STAFF RECOMMENDATION
128 Second Avenue North
August 19, 2015

Application: Violation
District: Second Avenue Historic Preservation Zoning Overlay
Council District: 19
Map and Parcel Number: 09306207900
Applicant: Nancy Jones, Possum Legend, LLC
Project Lead: robin.zeigler@nashville.gov

Description of Project: This application is for alterations made that do not match the permit and/or design guidelines. The applicant would like to request approval of the alterations.

Figure 1: Excerpt of plans from preservation permit

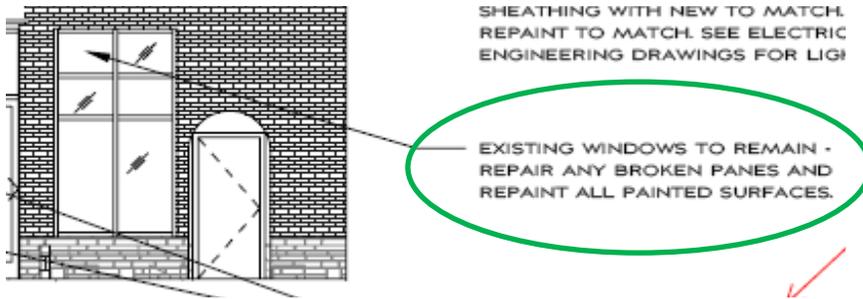
Storefront windows: The drawings submitted in December 2014 for alterations notes that there were no plans to alter the existing storefront windows.

The new storefront incorporates NANA walls with transoms above, which have been approved in the past. (See figure 3.)

The original storefront did not exist; therefore replacement is appropriate. The design guidelines state that replacement windows should mimic the original or be “compatible with the general appearance of the original. In this case, the windows are similar to a configuration approved through MDHA in 1996, with the advice of the MHC. Since a true replication of the original windows would not be conducive to the openness of first-level retail establishments, because the alteration is similar to one approved in 1996, and because the alteration is similar to historic storefronts found in the district, Staff finds the alteration to meet section II.A.3.

Figures 8 and 9: On the left is an example of historic industrial window that was a common alteration for First Avenue facades. The right shows the current alteration. The change in brick color shows how the opening was altered.

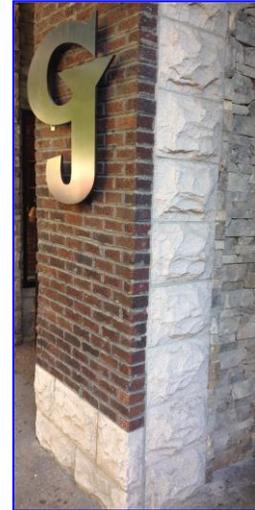
Windows: The First Avenue façade had a roll-up door on the second floor (1st level from Second Avenue). Roll-up doors are not appropriate on principle facades in the historic district; however, since the building already had existing doors, the applicant was advised they could keep them, as shown on the plans they submitted in December.

The applicant has replaced them with new roll-up doors that have changed the dimensions of the previous opening. Roll-up doors do not meet section III. H as they do not replicate the original windows nor are they similar to windows found on this style and period of building. Because the alteration does not meet section III.H of the design guidelines. Staff recommends disapproval of this alteration and that the roll-up doors be replaced with windows that meet the design guidelines. One option is to reestablish the punched, arched, window openings that were there originally. A second option would be to reestablish the previous opening, as it lined up with the windows above, and replace the roll up doors with windows that meet the design of industrial windows seen on multiple buildings on the First Avenue side and seen originally on the historic Second Avenue façade of this building. This is the same treatment that was recommended in 1996 when a previous owner proposed to change the windows.
